Remove GUFU originator field

| Brief Description (Subject) | Remove GUFU originator field from the FlightData class | | |

Model before Change

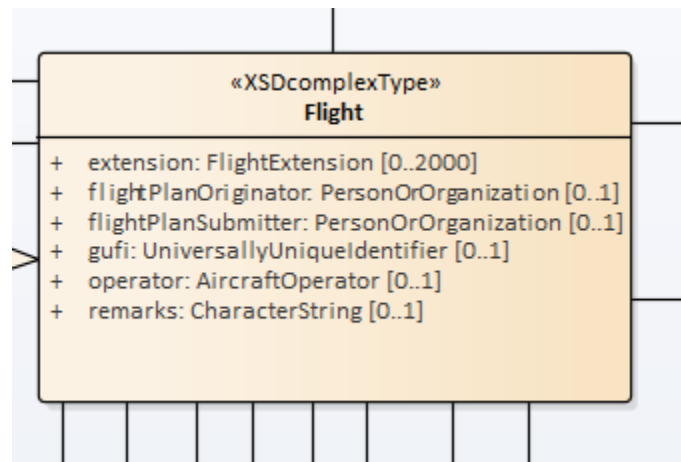
This field was last present in the FF-ICE IG in version 0.94 and was removed in version 0.95. Subsequent versions of the FF-ICE IG have not restored this field. It should be removed from FIXM.

Model after Change
